TECHNICAL BULLETIN		
	March 2010 TB 2528

Engine Coolant Loss On
2006-2008 GM 3.5 & 3.9L VIN N, K, R, W, 1, & 3 Engines

Bulletin Diagram: FIGURE 1. CYLINDER HEAD BOLT TORQUE SEQUENCE - CYLINDER HEAD

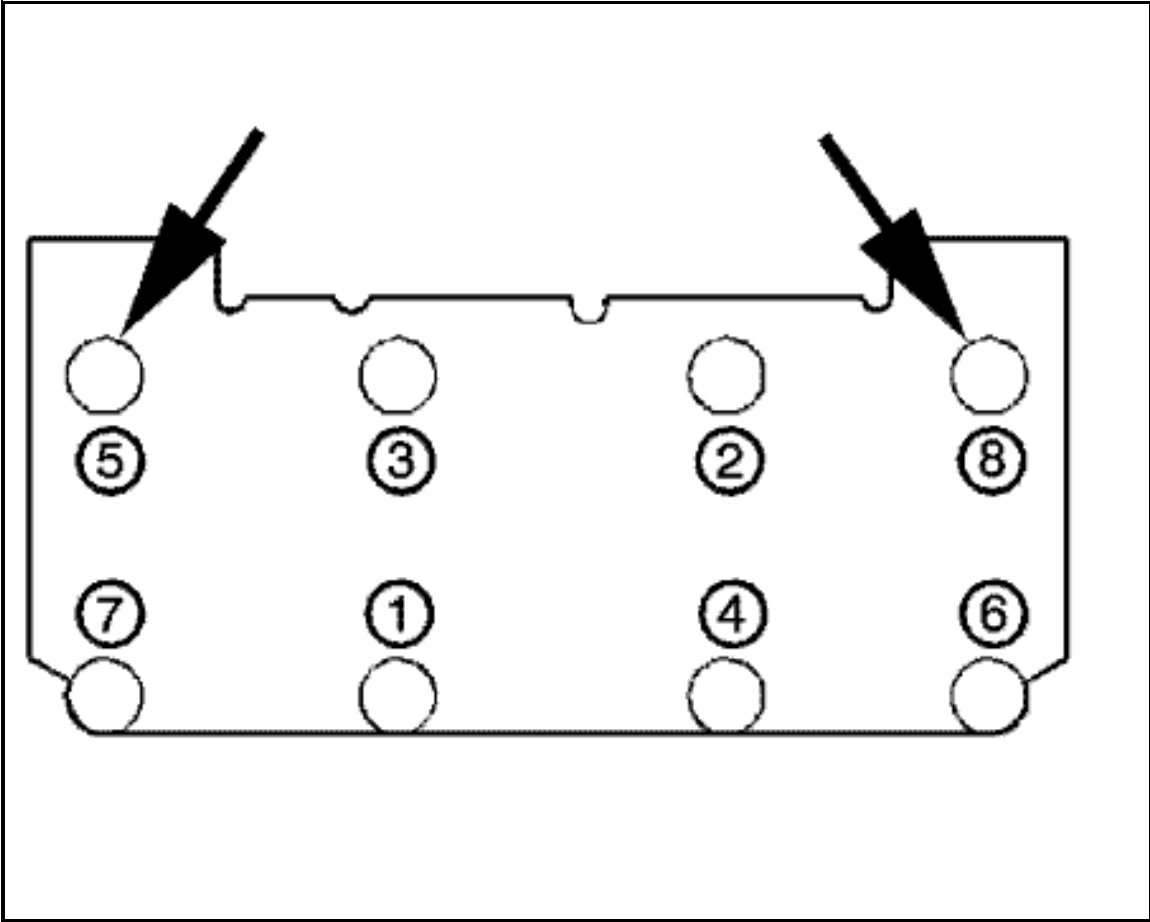
If a coolant leak is detected and determined to be coming from a cylinder head gasket, that gasket must be replaced. When replacing the head gasket, be advised that larger flanged hex head bolts are now to be used at head bolt locations 5 and 8. The larger flanged hex bolts are the same as the ones used at the other six locations. When installing the two large flanged hex head bolts at locations 5 and 8, a new style lower intake manifold gasket must be used. That intake manifold gasket has provisions to allow for the larger flanged bolts that are recommended to be used. These new lower intake manifold gaskets are contained in the gasket kits listed below. Also Note: Replace the other six cylinder head bolts during this head gasket renewal process.

Caution: Failure to use the new lower intake manifold gaskets when installing the larger flange hex head bolts at locations 5 and 8 may result in the lower intake manifold not fitting properly, which may result in a leak condition.

To install the cylinder heads on these engines follow the steps listed below and reference figure 1 for the sequence to tight the bolts.

1. Install the NEW cylinder head bolts and tighten all bolts finger tight.
2. Tighten all bolts in sequence to 44 FT/LBS (40 Nm).
- 3 .Rotate all bolts in sequence an additional 95° turn using torque angle tool J45059.
